Access Compliance Report Public Rights-of-Way (Curb Ramps)

Intersection ID: 12427 Main Street: W_STONEWALL_ST Cross Street: S_MINT_ST Location: E

ADA ID: 552D2890881A Ramp Type: Perp Initial Pass/Fail: Fail Overall Compliance: No Severity Score: 12.5

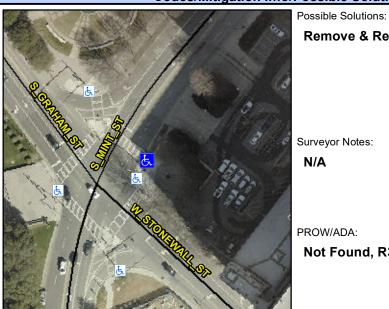
PROW/ADA:
Not Found, R304.5.3

| Field Measurements/Component Compliance | | | | | |
|-----------------------------------------|-----------------------|-------|------|-----------------------------|------|
| Yes | Ramp Width (in) | 68.0 | No | Ramp XSlope (%) | 5.2 |

Remove & Replace Entire Ramp.
